## NSUR - Control Board

TITLE: NS\_ARM\_Control\_07\_17\_2017

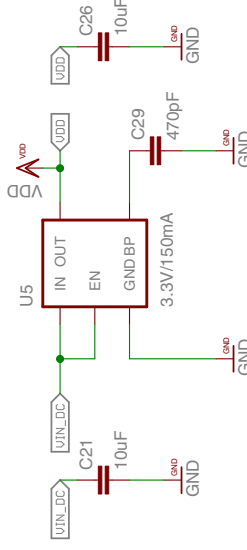
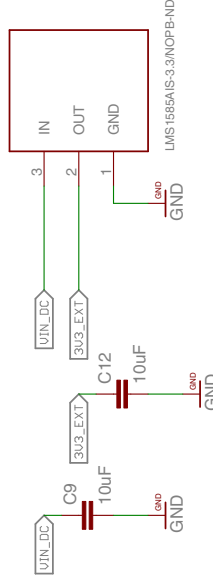
**NOTE :**  
There are no pullup resistors on the downstream hub lines---  
You are depending on having them on the downstream devices!
